An Bord Pleanála Opinion Response Report (Architectural Items)

THE MEADOWS

BESSBOROUGH
BLACKROCK
CORK

MARCH 2022

Bessborough House (BH) Building A Building F

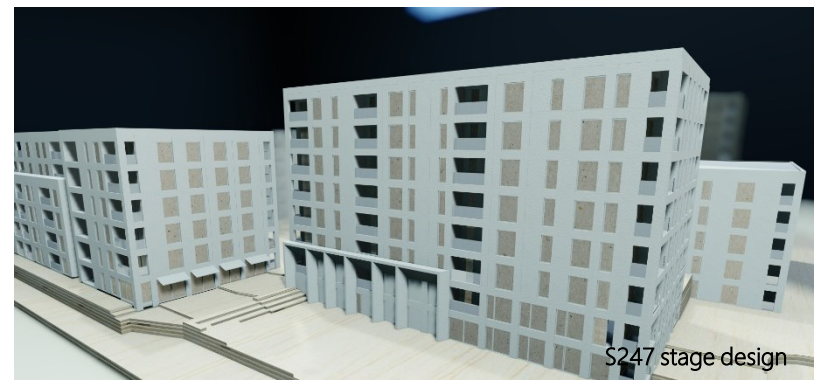
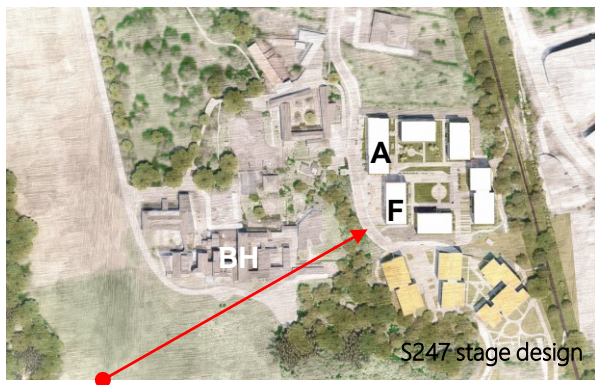
-  Condition Area A - Building height receiving capacity – Relationship to protected structure – Bessborough House (PS 490).
-  Condition Area B - Building height receiving capacity - Distant cross valley and protected views from south.
-  Condition Area C - Building height receiving capacity – Southern intermediate distant views.
-  Condition Area D - Building height receiving capacity – Northern approach and northern lands relationship.
-  Condition Area E - Building height receiving capacity – Eastern approaches and greenway.
-  Condition Area E - Building height receiving capacity - Relationship Farmyard complex (N.I.A.H. -20872006)

From early consideration of 'Condition Area A', site specific conditions are relevant to the height receiving environment for the buildings located to East of Bessborough House. Of note is the topography which is 10 meters lower to the lower far south west corner of the site. This elevates with the prominence of the 3 storey protected structure to a commanding presence over the historic demesne landscape to the foreground. This open landscape is highlighted as highly sensitive (A below) in Forest Birds historic landscape report (Appendix iii).

Early analysis prior to first S247 meeting explored this height relationship in then buildings A & F to the West of the proposal. With datum level accurate modelling, this distant view was carefully considered. At this stage of the design process Buildings A & F were proposed at 6 – 8 storeys. The application proposal has revised the Western built forms to 5, 6 & 7 storeys at this location, with a rear building (B) presenting in the far distance at 10 storeys. Also, considerable adjustment was made throughout the design phase to move away from the more mono-block approach to introduce more de-massing mechanisms of steeped forms, façade expressions, material breakups and setbacks.

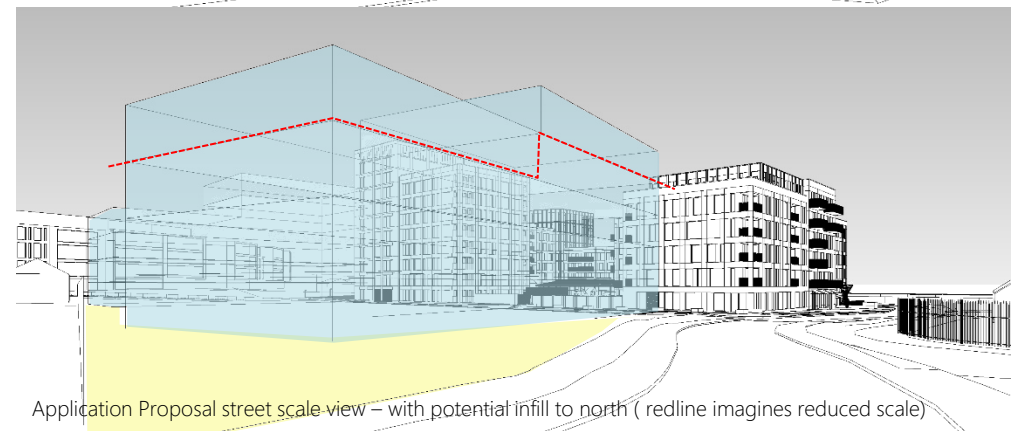
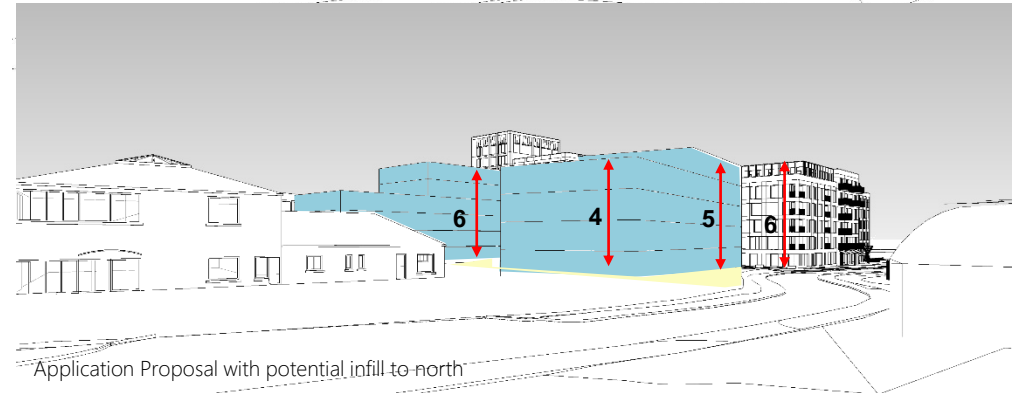
In assessing intermediate distant views from the south, a critical component in measuring this impact is the recognition of the potential for future dense development to the southeast boundaries residential zoned lands outside the applicants ownership (A). This land holding has been subject to 2 recent applications for MBW TWO Ltd .

Prior to these refusals on this southern site the design team modelled the southern proposals to assess the buffer impact for development of the eastern boundary to the greenway holistically. The application proposal is designed to accept southern development in location A which will eclipse and diminish impacts intermediate distant views from the south

It must be noted the reasons for refusal on both MWB TWO Ltd applications was not for height issues per say, with the inspector noting in (site Z) ABP 309560-21

Contextual section drawing .

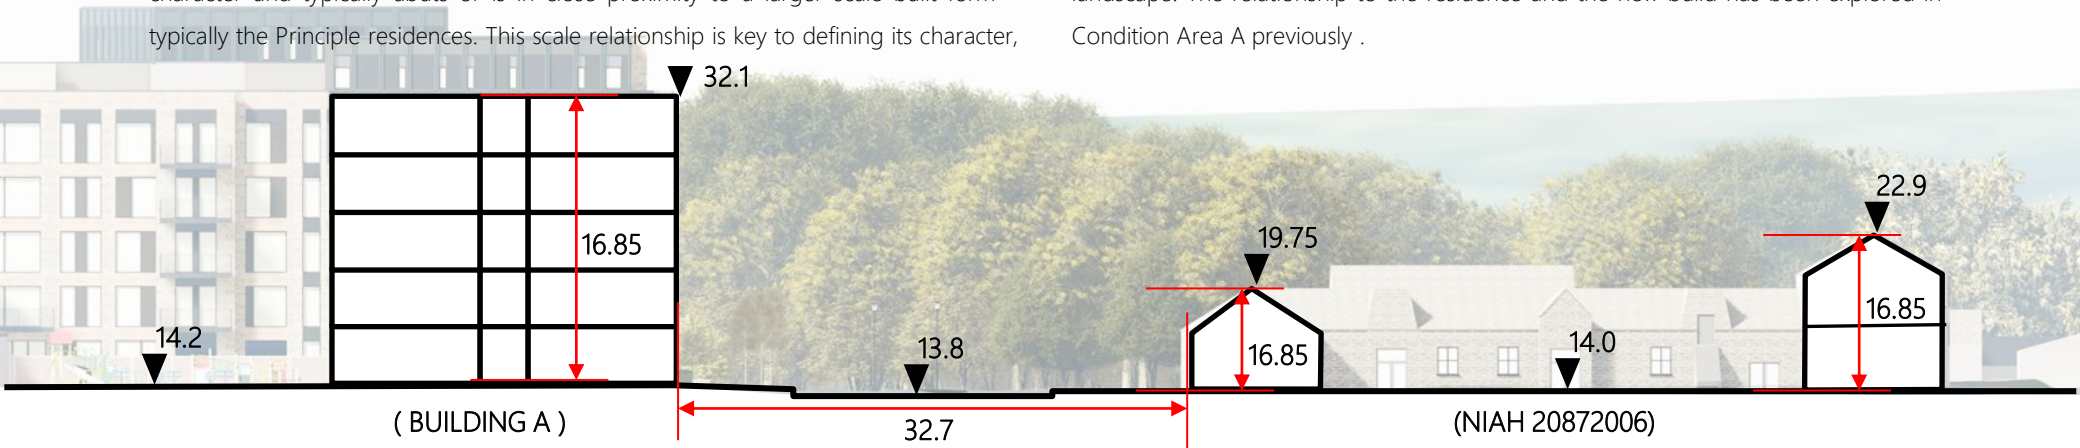
'The application should clearly illustrate and assess the relationship between the proposed development and the adjoining farmyard complex and walled garden to the west, identified in the National Inventory of Architectural Heritage (reg. no. 20872006), having regard to the height and scale of development proposed. Detailed section and contextual drawings and other imagery should be submitted in this regard.'

The relationship of building A of the proposed development and the Farmyard complex to the East is explored in below context sectional drawing, A further more detailed section is provided in the drawing submission pack. In assessing the height potential of application in this proximity appropriate to this heritage item, it is considered the low scale of this assembly of buildings is part of its own inherent character and typically abuts or is in close proximity to a larger scale built form – typically the Principle residences. This scale relationship is key to defining its character,

and the farmyard complex should not have new development matching its scale as this would detract from its unique characteristic. An adjoining scale that highlights this unique scale characteristic we feel is appropriate in this context. Critically the scale relationship of any new Build to the former residence is the more sensitive relationship as this is intended to present as a large scale dominant presence in the historic landscape. The relationship to the residence and the new build has been explored in Condition Area A previously .

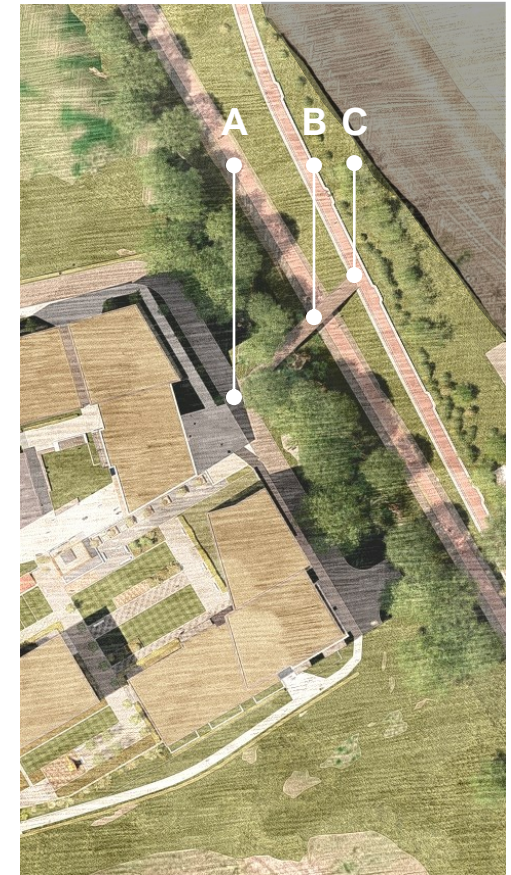
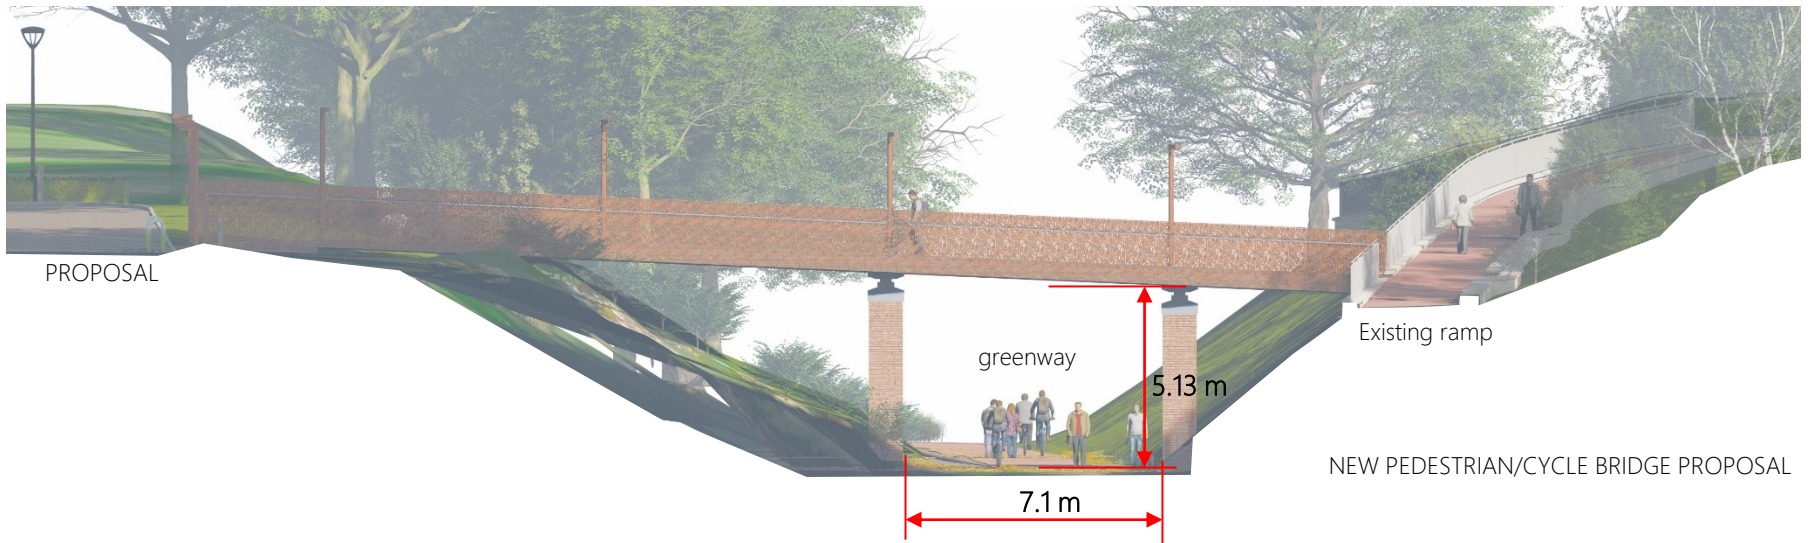
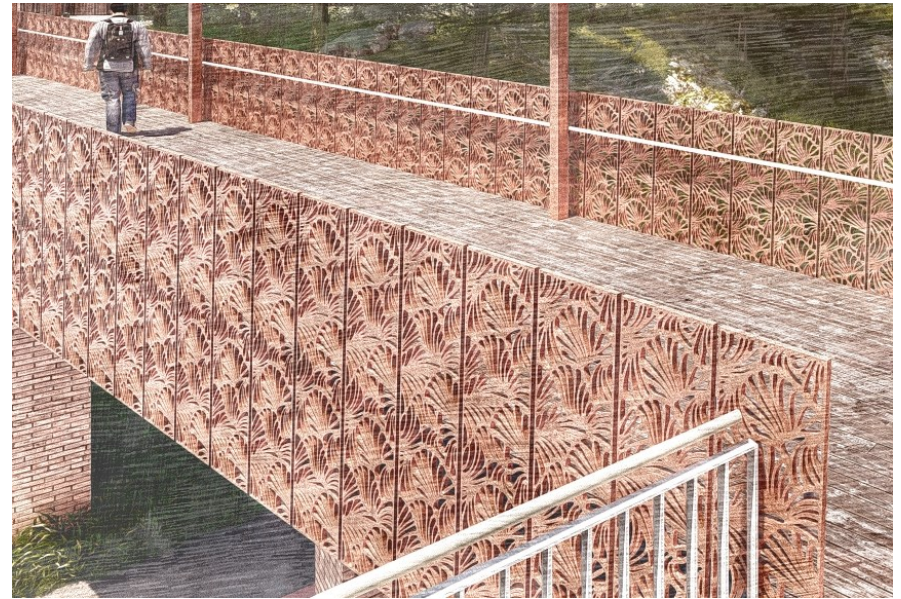
Detailed design proposals for the proposed Greenway access bridge should be provided, which should address the matters raised in the submission of the Planning Authority to An Bord Pleanála dated 15/10/2021, including a rationale for the siting and design of the structure, a requirement for an increase in the width of the bridge, interaction with the existing Greenway and issues of wayfinding.

The Bridge design has been modified through engagement with Cork City Council (CCC) post Tri-Party engagement phase. The Bridge now has a clear width of 3.15 meters, width clearance of 7.1 meters and height clearance of 5.13 meters per CCC request. Also of note is the design incorporates 2 supporting piers compared with 1 previously, as concern was expressed as to the bearing capacity next to the existing ramp. The geometry of the bridge was also minorly adjusted slightly in plan to meet the existing ramp at a more northerly and higher point and facilitate the clearance required by CCC.

The expression of structure is traditional in perception while composed with contemporary building fabric materials. A decorative panelised system in Corten steel is used as the main design feature on the main bridge transept guardrail standing on 2 simple formed brick piers.

'.....The proposed bridge now makes adequate provision for the possible future provision of light rail and so is acceptable to the Infrastructure Development Directorate in regard to planned future infrastructure. I note the clear width of the bridge has been revised to 3m clear width. This is acceptable to the Infrastructure Development Directorate noting the width of the existing ramp.'

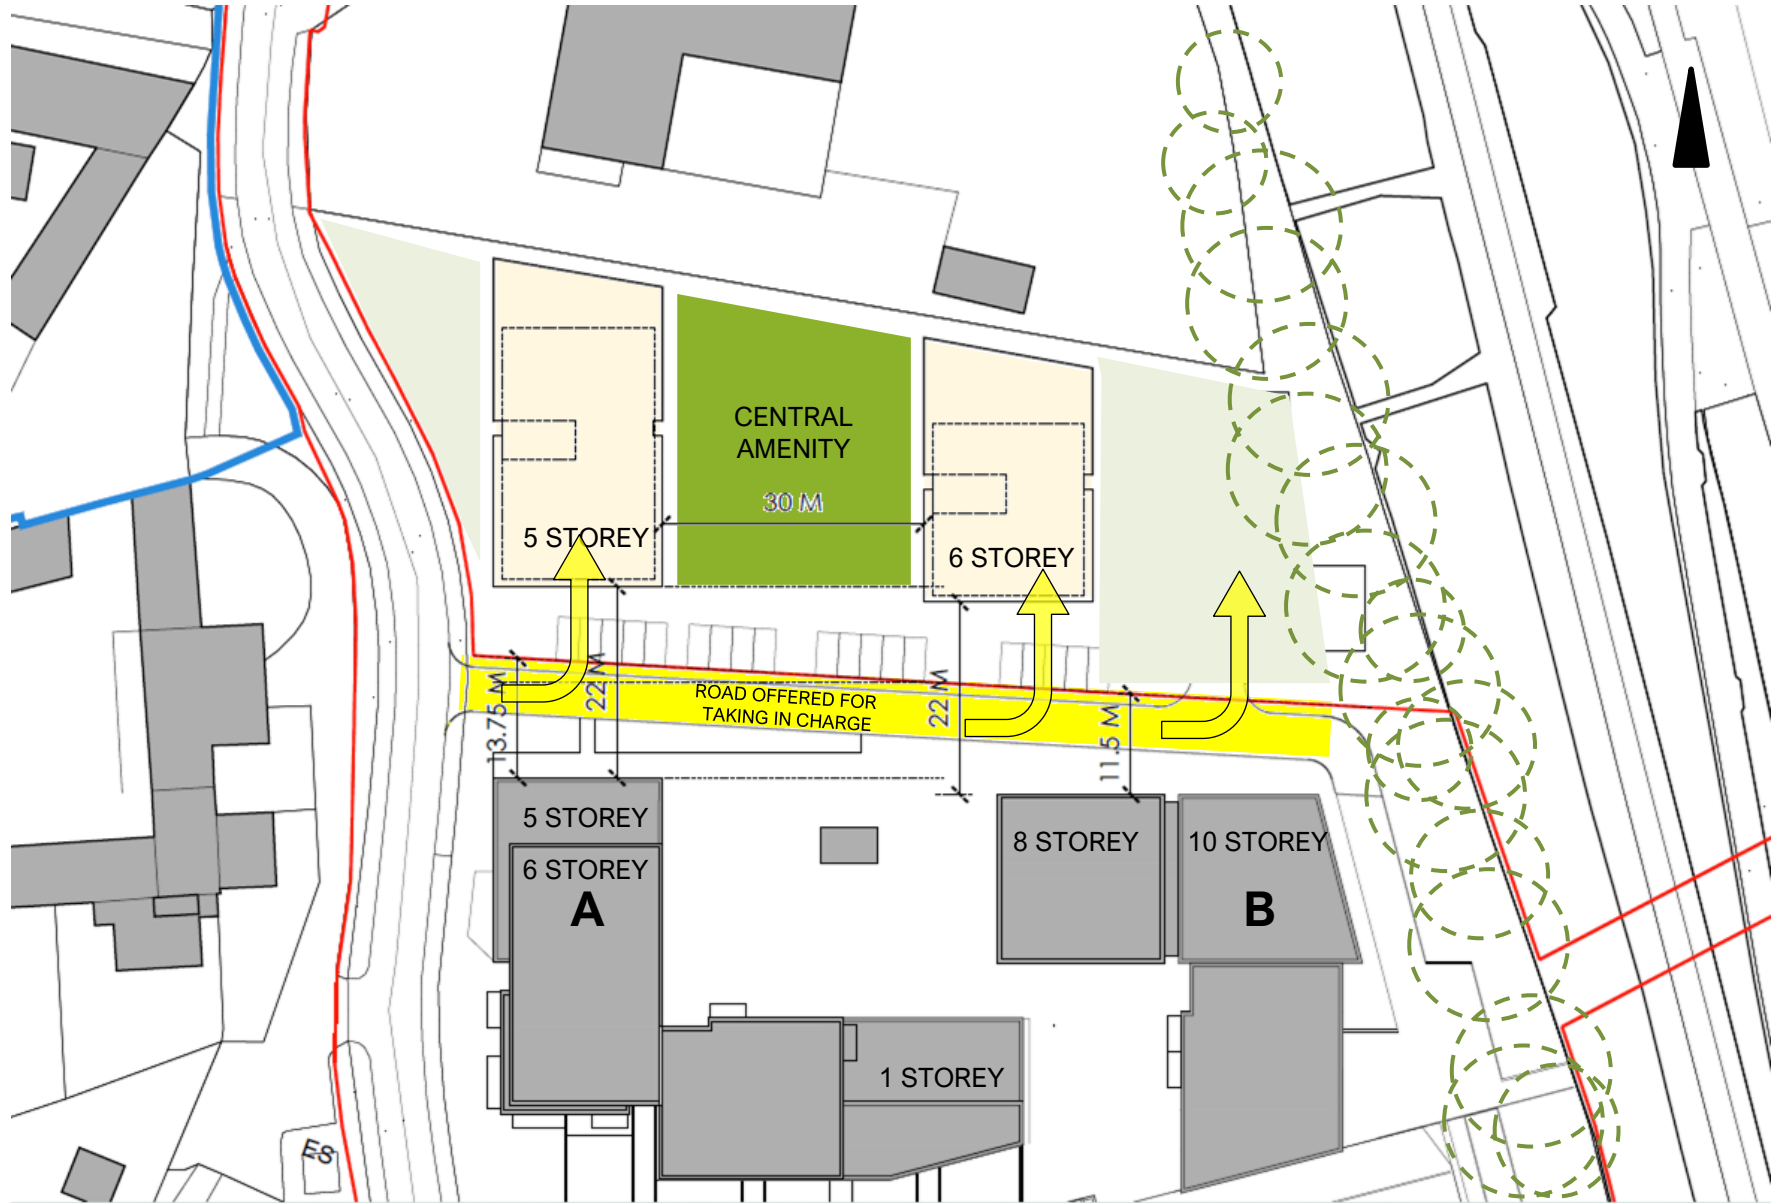
'Further consideration of, and possible amendment to the documents and/or design proposals submitted, having regard to the relationship of the proposed development with the adjacent lands to the north. It should be demonstrated that the proposed development would not prejudice any future development of those lands, having particular regard to issues including overlooking, daylight, sunlight and overshadowing.

The application site has strategically set its building line to a minimum of 11 meters for the Northern boundary, this with an 11m set back on the Northern site will allow for orderly development with a 22m separation between facing Apartments. By location of the applicants higher built form to the rear (North East) corner of the site, a potential amenity space to the Northern site is aligned with a break in the applications building A & B allow for quality of southern light to penetrate the site.

Overleaf demonstrates the dimensional set up of critical set out distances. A further shadow study is included based on the indicative scheme which demonstrates the quality of light achieved in the central amenity space on March 21st assessment date.

On analysis we conclude that the proposal does not adversely impact on the development potential of the lands to the North , distances being within guidelines for acceptable proximities and shadow cast be within BRE acceptable limits .
